REVISED RESPONSE TO REQUEST FOR ADDITIONAL INFORMATION**APR1400 Design Certification****Korea Electric Power Corporation / Korea Hydro & Nuclear Power Co., LTD****Docket No. 52-046**

RAI No.: 179-8190

SRP Section: 09.01.01 - Criticality Safety of Fresh and Spent Fuel Storage and Handling

Question No. 09.01.01-15RAI 9.1.1-9: Deformation of neutron absorber material**REQUIREMENTS AND GUIDANCE**

Figure 2.4-2 Criticality Calculation Model for a Dropped Fuel Assembly Accident (Contact)

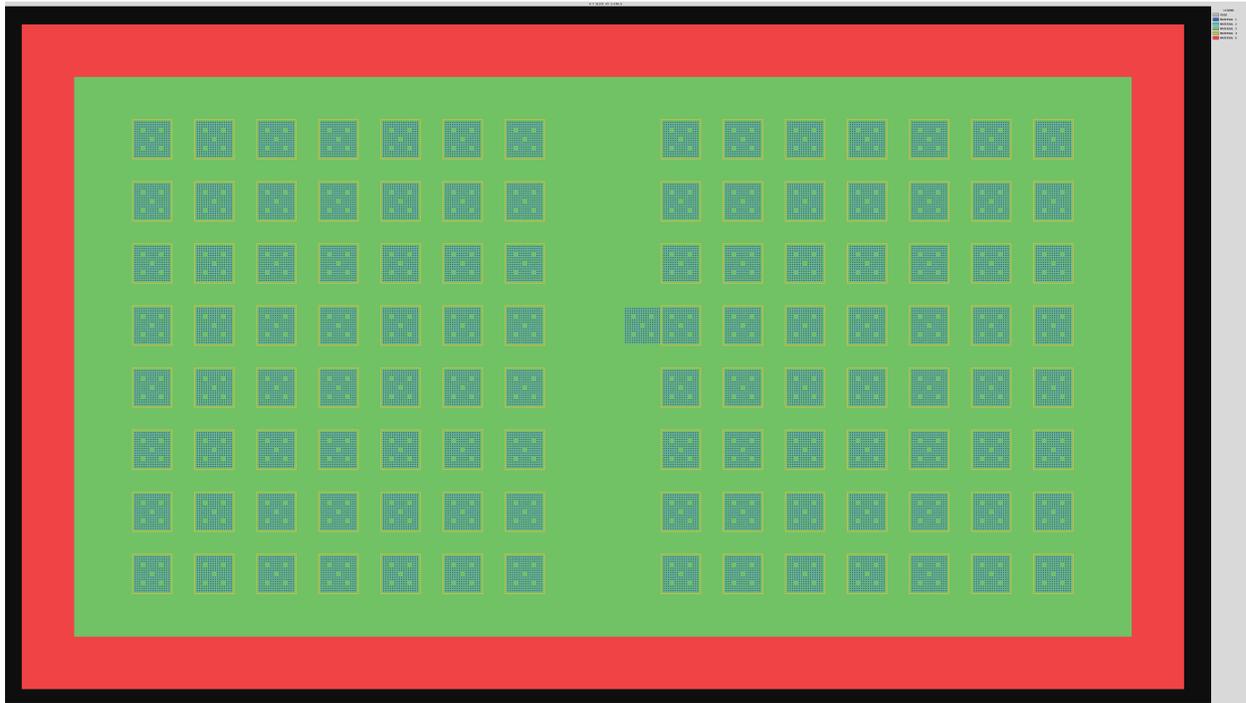
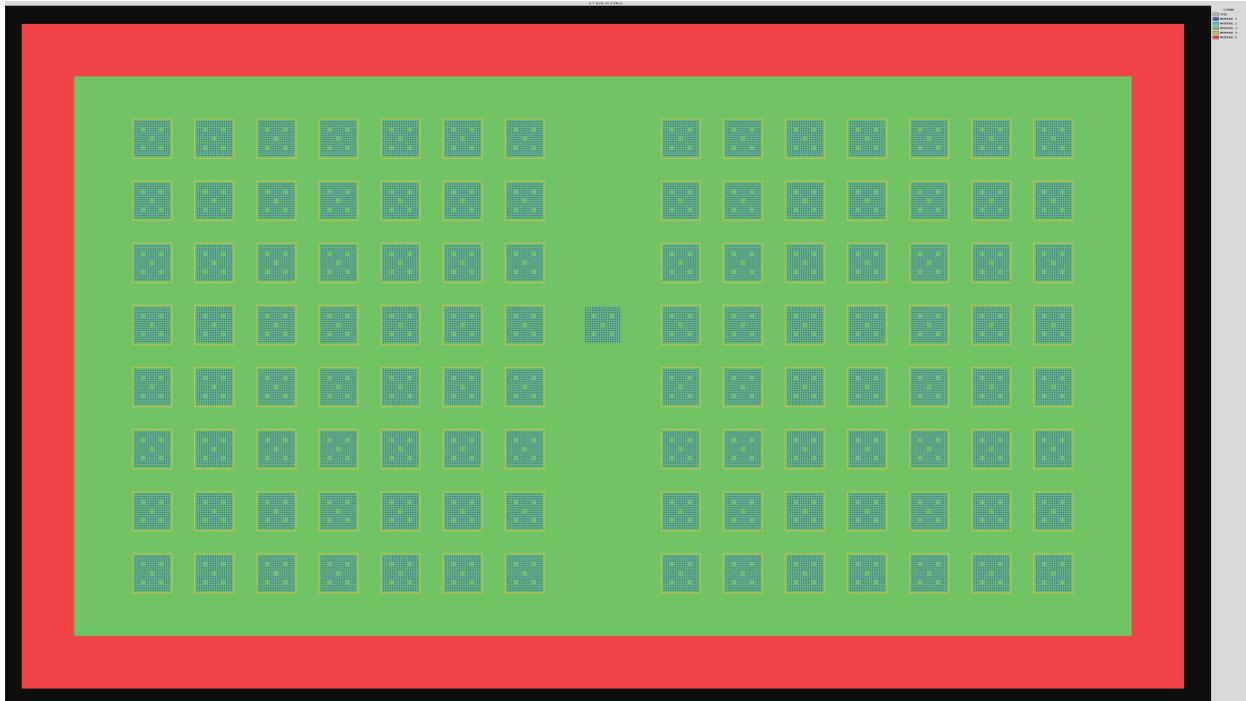
The applicant should describe in its response and in the DCD or its incorporated references additional sensitivity calculations on an analysis model that addresses the neutronic effects of storage pit concrete as well as the respective conditions of optimum moderation by low-density water and moderation by full-density water. The results of the supplemental

Sensitivity calculations on a finite array model describing the new fuel racks with storage pit concrete in optimum moderation and full-density water conditions have been performed to obtain uncertainties due to design tolerances. The criticality analysis TeR will be revised to include the sensitivity calculation results.

Sections 2.4.2 and 2.5, Tables 2.4-3, 2.4-4, and 2.5-1, Figures 2.4-2, 2.4-3, and 2.5-1 in the criticality analysis TeR will be revised as indicated in the attachment.

This figure should be replaced with page 9 of Attachment.

Figure 2.4-2 Criticality Calculation Model for a Dropped Fuel Assembly Accident (Contact)

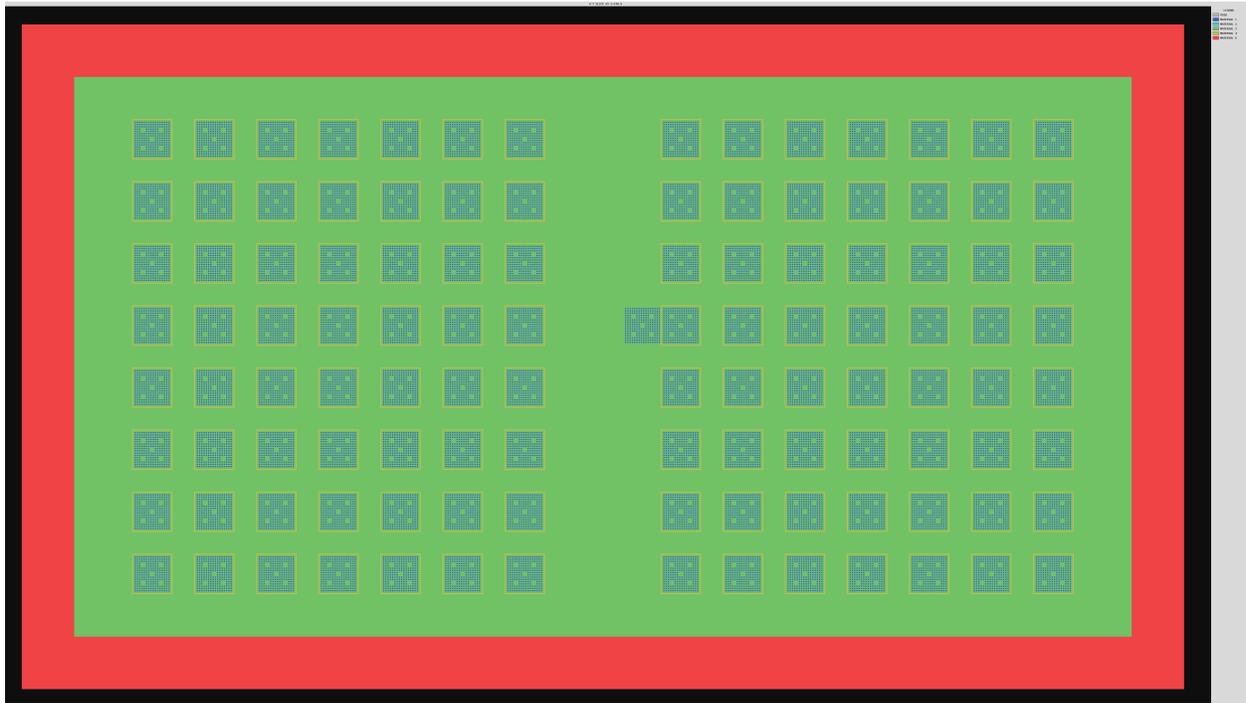
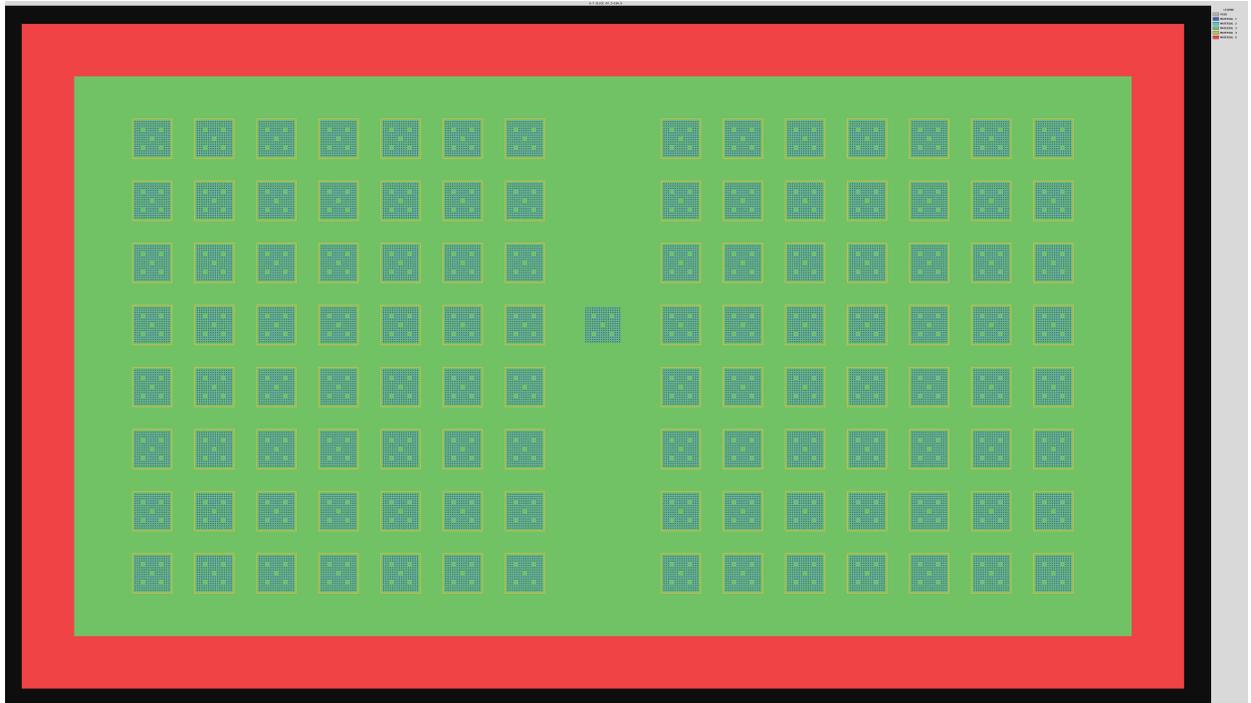
In its response and in the DCD or its incorporated reference, the applicant should either (1) provide justification for not including the uncertainty in uranium enrichment and both positive and negative dimensional variations or (2) update the sensitivity analysis for the new fuel storage racks to include these tolerances and apply the revised results to the new fuel storage rack criticality analysis accordingly.

Sensitivity analysis for the new fuel storage rack criticality uncertainty evaluation has been performed to include additional items such as uranium enrichment and both positive and negative tolerances in dimensions, such as fuel rod pitch, fuel clad diameter, and rack cell thickness. Criticality analysis TeR will be revised to include the additional sensitivity calculation results.

Sections 2.4.2 and 2.5, Tables 2.4-3, 2.4-4, and 2.5-1, Figures 2.4-2, 2.4-3, and 2.5-1 in the criticality TeR will be revised as indicated in the attachment.

This figure should be replaced with page 9 of Attachment.
